**Water Resources  
Report on the Santa Clara River**

**Prepared by United Water Conservation District  
Castaic Lake Water Agency**

**April 1996**

CLWA & Purveyor Boundaries and Precipitation Gage Sites  
 April 1996  
 Source: Kennedy/Jenks Consultants  
 Figure 2

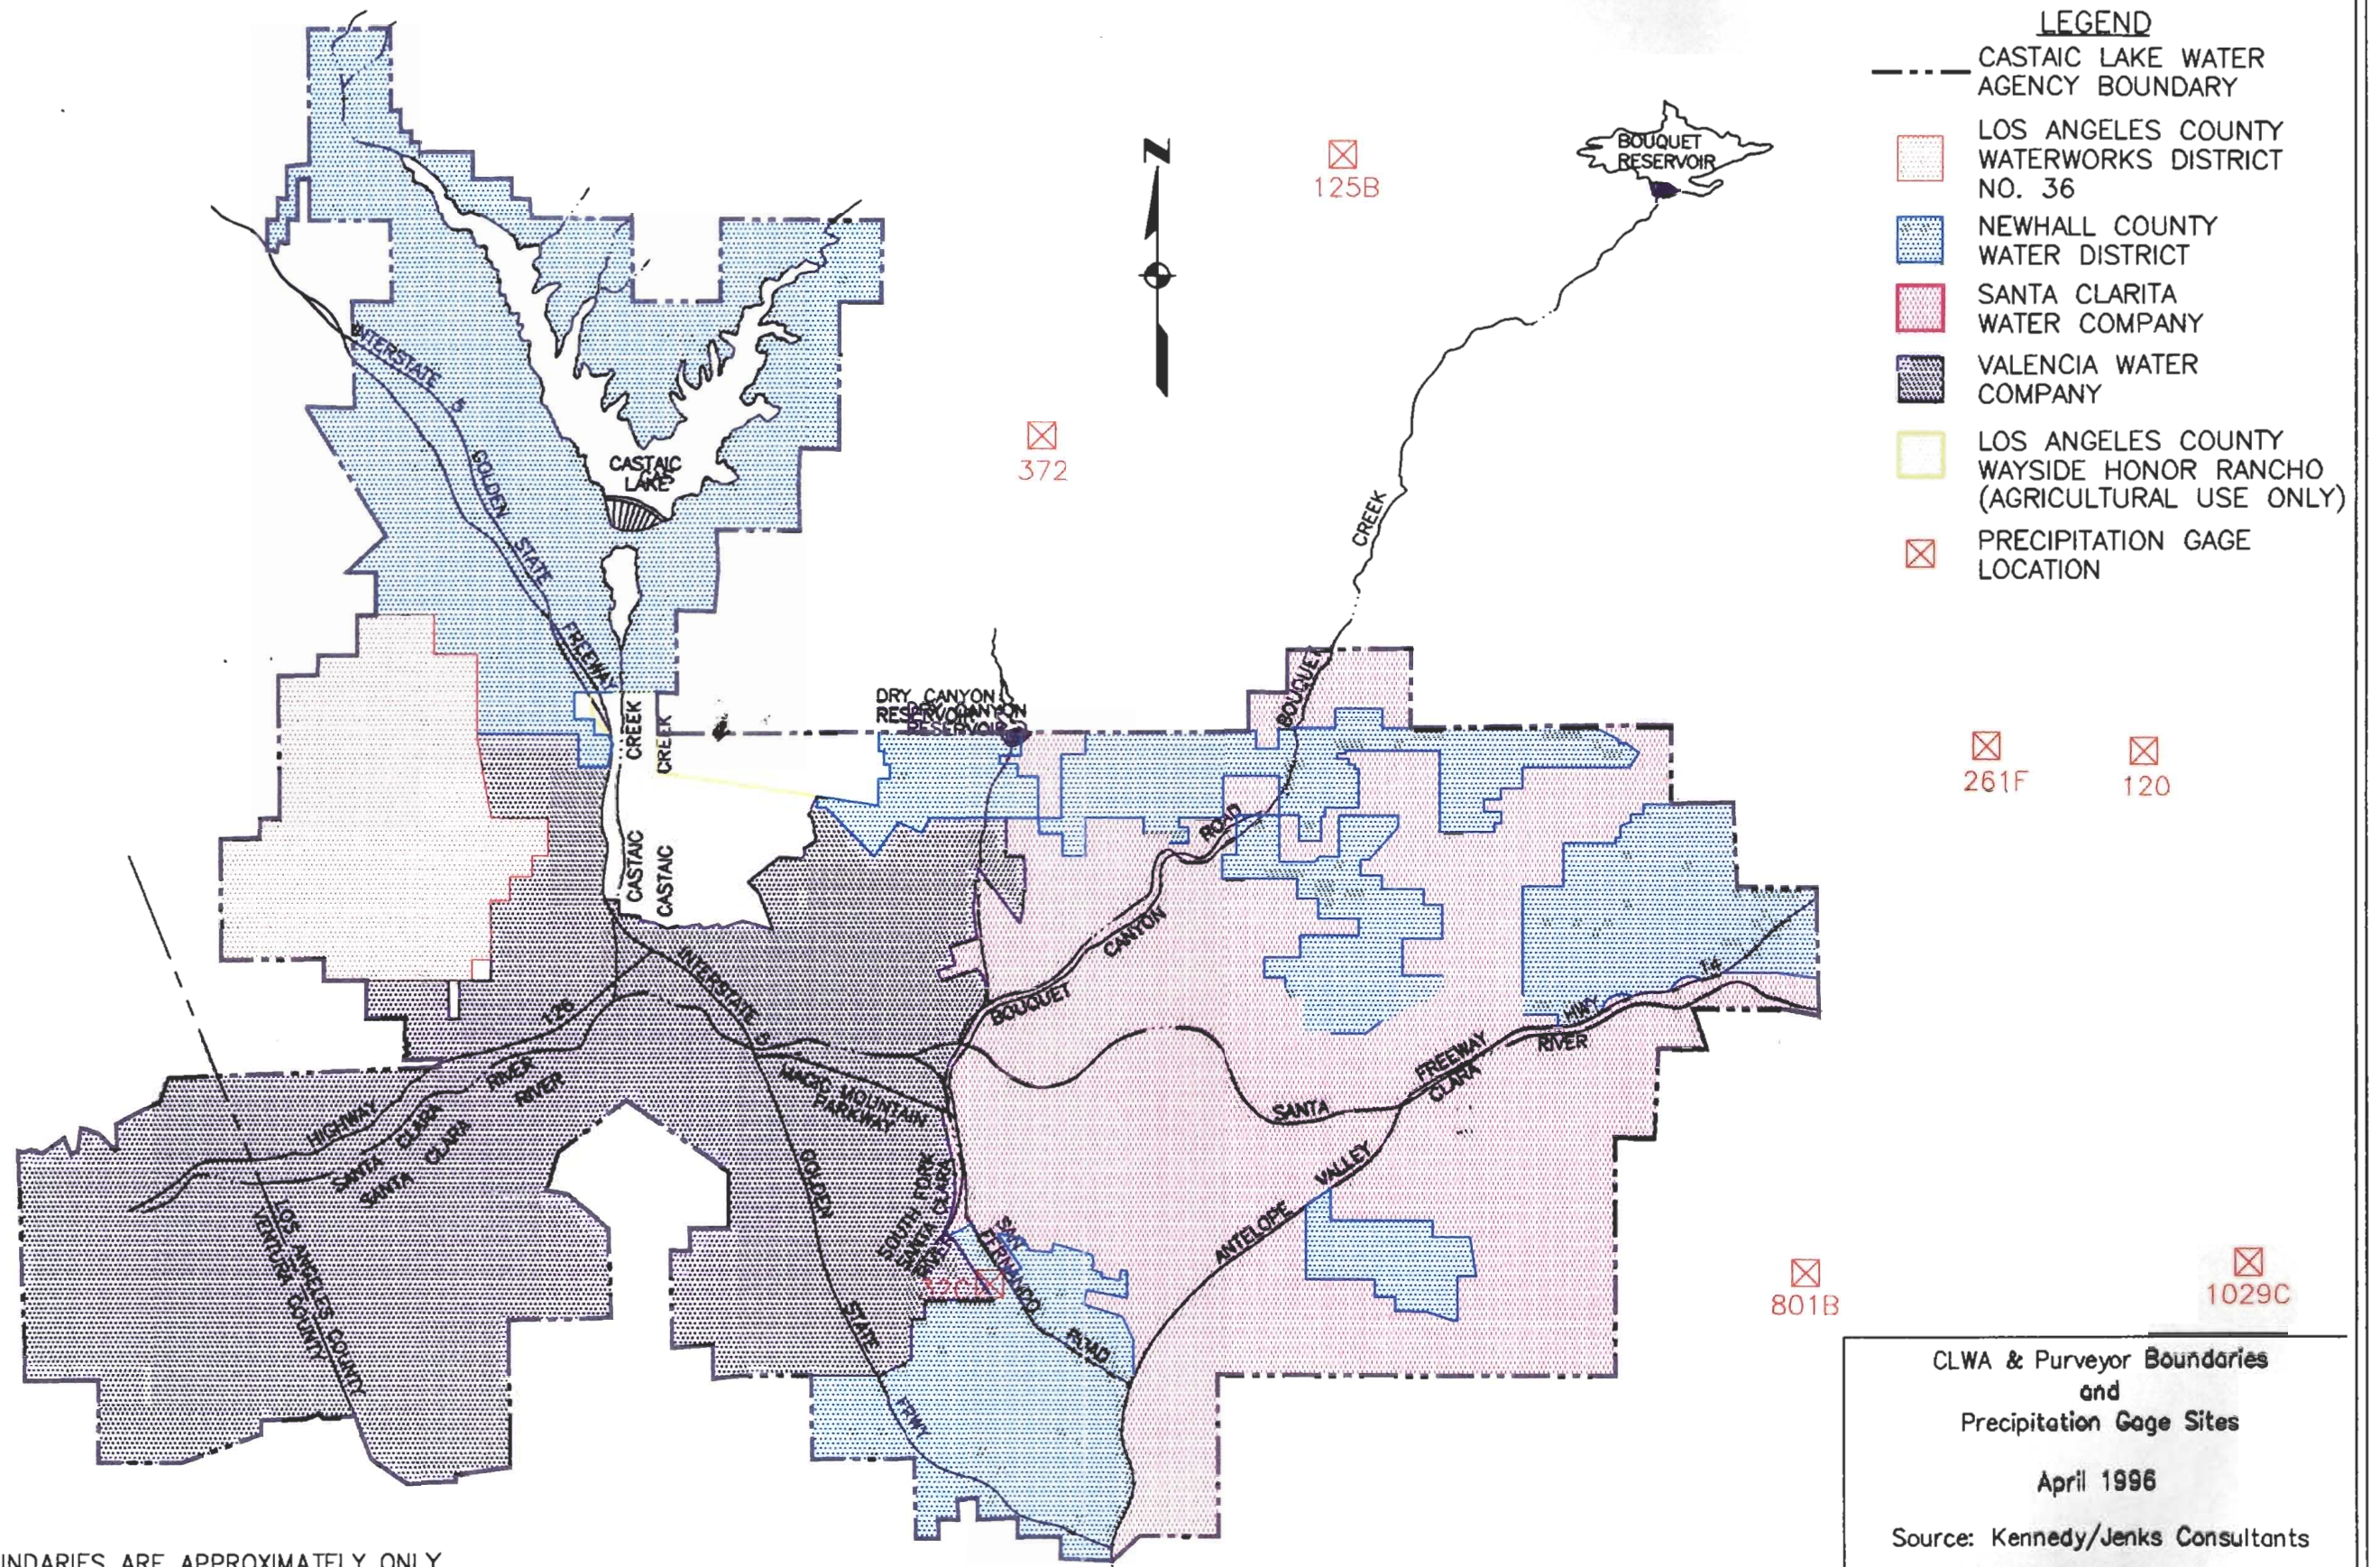
- D1 Figure 2. It should be noted that boundaries indicated on this map are not exact.
- D2 Pg. 1-13: Paragraph labeled *Alluvial Aquifer*. Elsmere Canyon and Newhall Creek should be listed, along with Whitney and Placerita Canyons, as replenishment located south of the basin. They are indicated in the most recent version of the Water Quality Control Board Basin Plan and serve as recharge to several Newhall County Water District wells.

- D1. Figure 2, comment was incorporated.
- D2. Page 1-13: Based upon our review of the cited Water Quality Control Board Basin Report, Elsmere Canyon and Newhall Creek are not specifically listed as replenishment areas on the south side of the groundwater basin, only Placerita Canyon is. The larger replenishment areas were included. The list is not inclusive of all the smaller drainages.

Location of Soledad Canyon Alluvial Channel  
 April 1996  
 Source: Kennedy/Jenks Consultants  
 Figure 5

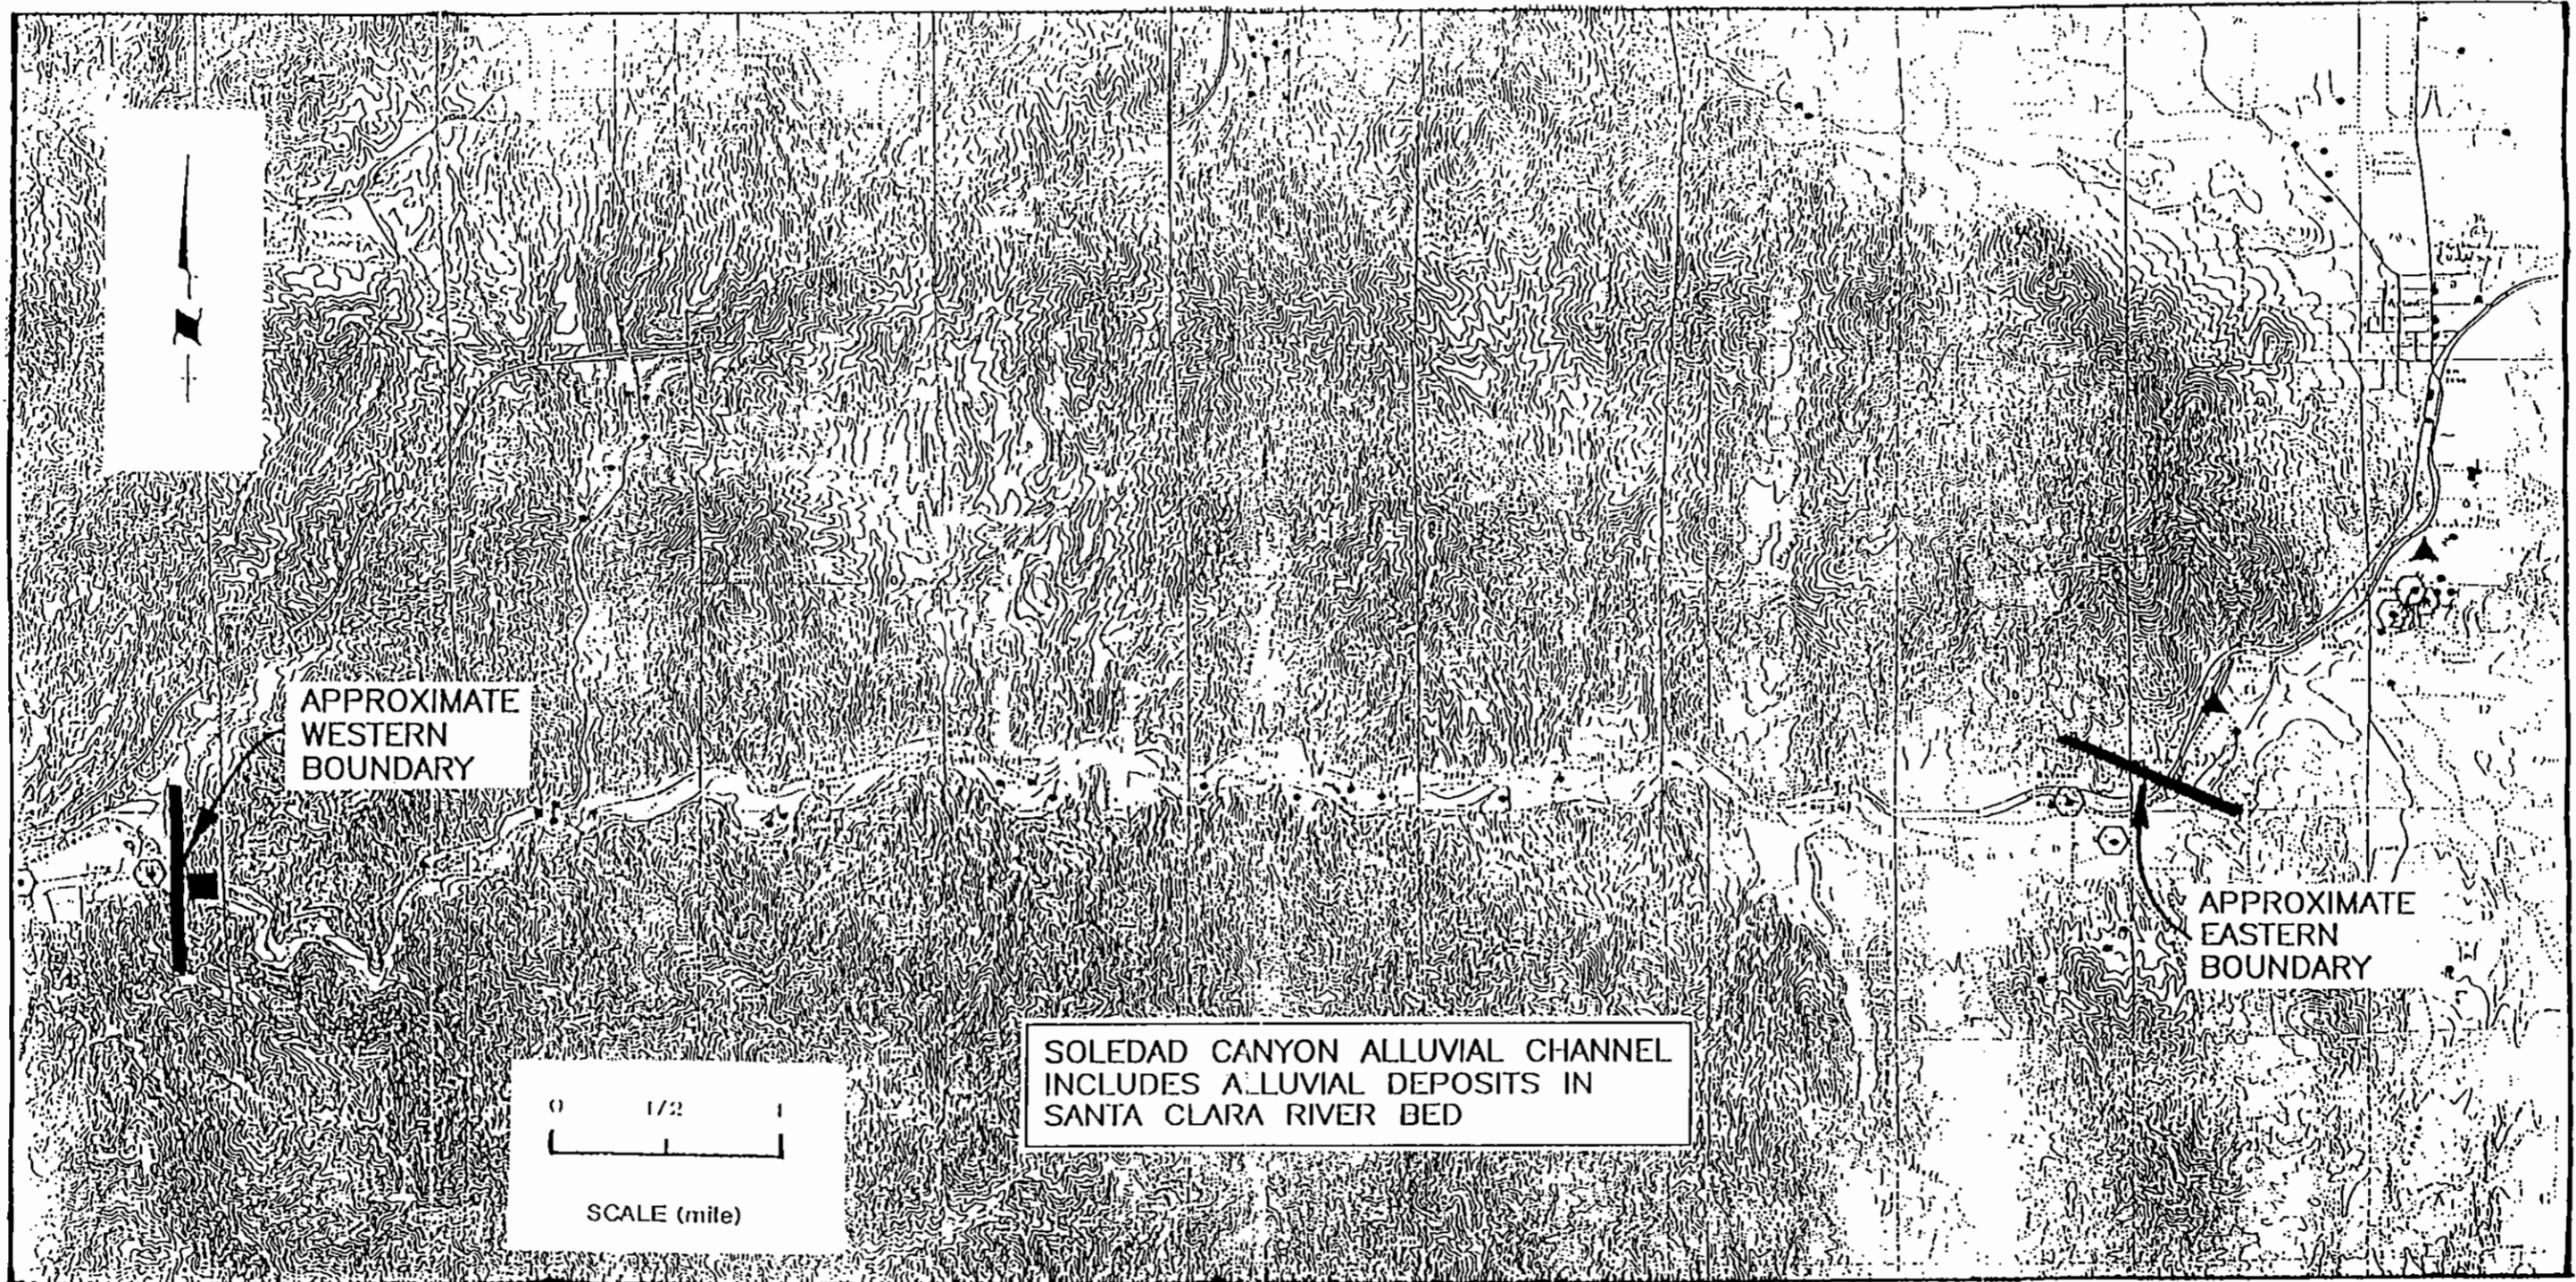
C1 Page 1-9 and Figure 5: Should reference to the Soledad Canyon Alluvial Channel be "aquifer" rather than "channel"?
